SERVICE BULLETIN

APPLICABILITY: 2015-2017MY Legacy

NUMBER: 12-226-17R

SUBJECT: Fuel Door Sticking Closed in Cold Weather

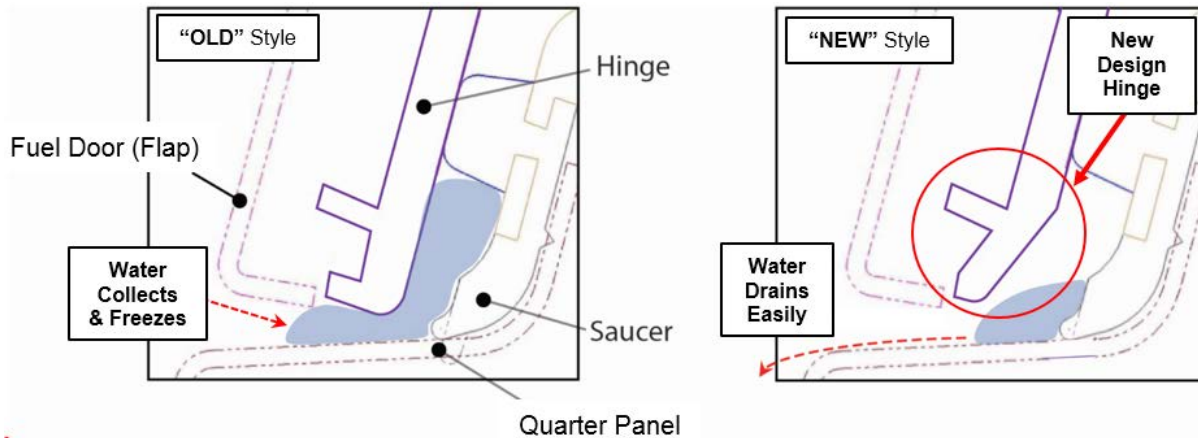
The illustrations below provide a comparison between the “NEW” and “OLD” -style parts. The change involves a change made to the base of the hinge portion to improve drainage and prevent water accumulation. In sub-freezing temperatures, ice can form causing the fuel door to not open properly.

The new saucer assembly was incorporated into production during mid-August, 2017.
